SUBJECT: W.P. 35-66-14, Site 27-212,
County Road 3 Overpass,
(2.2 Miles West of Casselman),
Highway 417, District 9-Ottawa

FOUNDATION INVESTIGATION REPORT
For
Proposed Crossing at Hwy. 417
Eastbound and Westbound Lanes
Add County Road No. 3
Twp. of Cambridge - Co. of Russell
District No. 9 (Ottawa)
W.J. 70-F-2 -- W.P. 35-66-14

FOUNDATION INVESTIGATION REPORT
For

Proposed Crossing at Hwy. 417
Eastbound and Westbound Lanes
And County Road No. 3
Twp. of Cambridge - Co. of Russell
District No. 9 (Ottawa)
W.J. 70-F-2 -- W.P. 35-66-14

Fig. No. 6

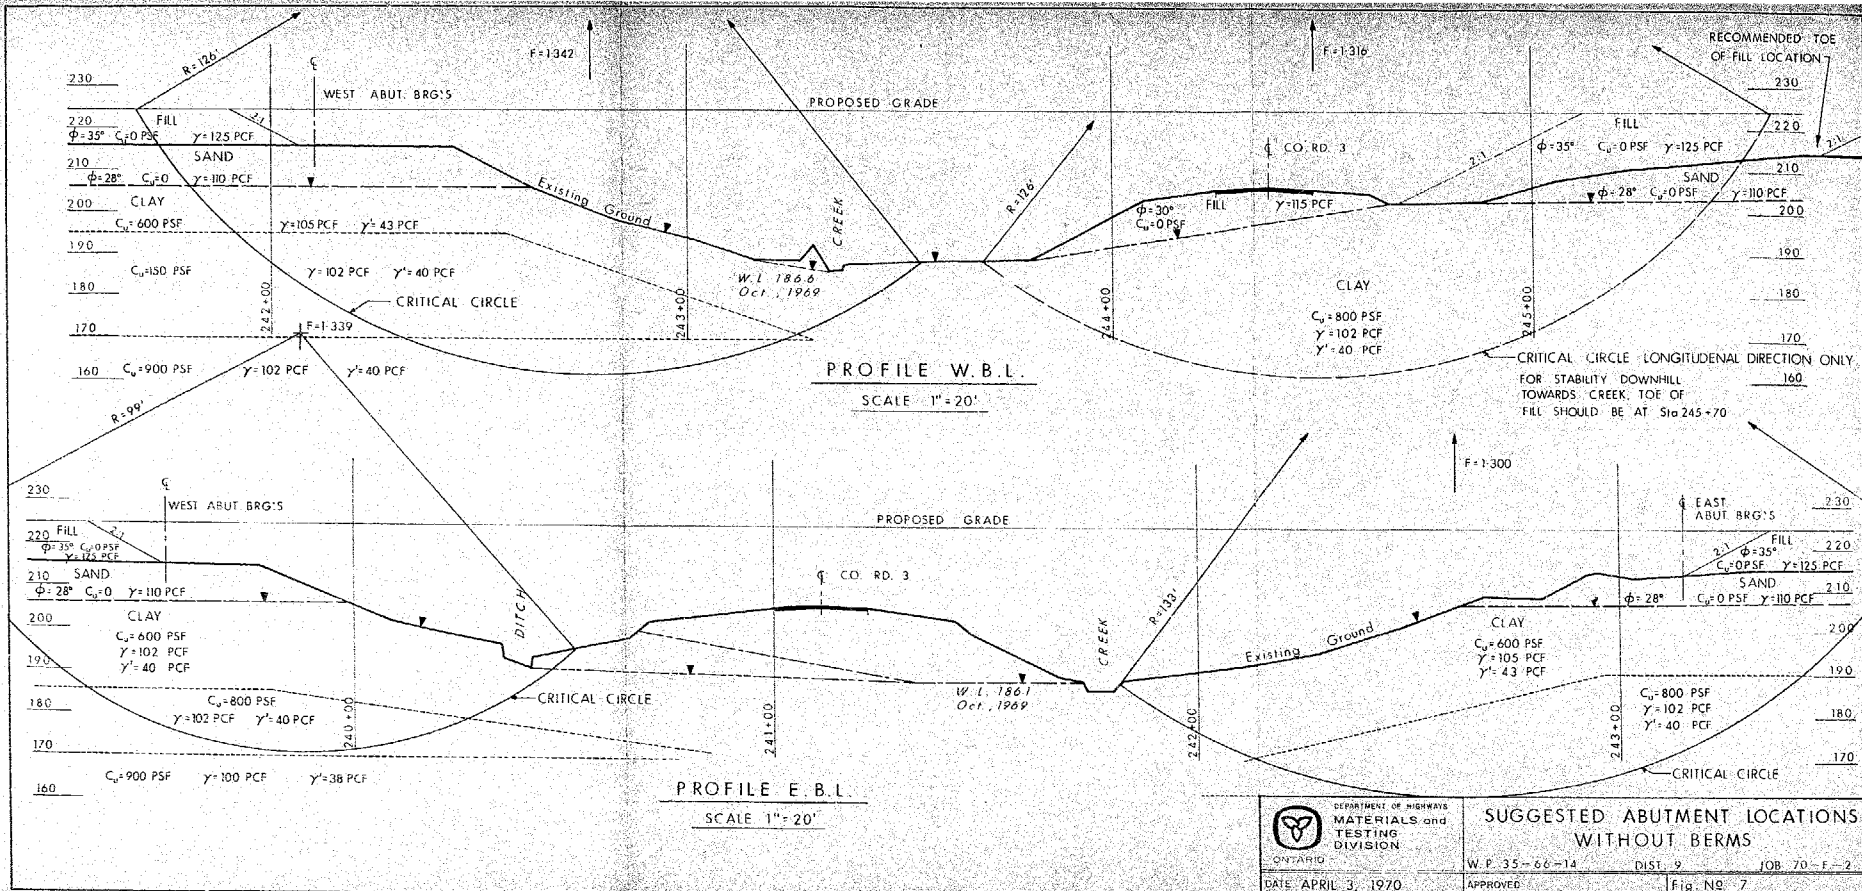
ii) For the west approach, a berm constructed to elev. 208 is required in order to improve stability in the longitudinal direction, as shown on Fig. 6.

ii) In the longitudinal direction for the suggested three-span scheme, fills with standard 2:1 slopes will not be stable. In order to improve stability in the longitudinal direction a berm up to elev. 208 will be required for both east and west approaches as shown on Fig. 6.

2 Bearing of West Abut. (2) -
Sta. 242+20 - changed to Sta. 242+10.

2 Bearing of East Abut. (2) -
Sta. 244+91 - changed to Sta. 245+78.

2 Bearing of West Abut. (2) -
Sta. 239+60 - changed to Sta. 239+55.

2 Bearing of East Abut. (1) -
Sta. 242+47 - changed to read: "To suit Bern shown".

In view of the foregoing revisions, would you kindly delete from your copy(s) of the mentioned report pages 10, 11 and 13, and insert revised pages, as well as revised Figures 6 and 7, attached hereto.
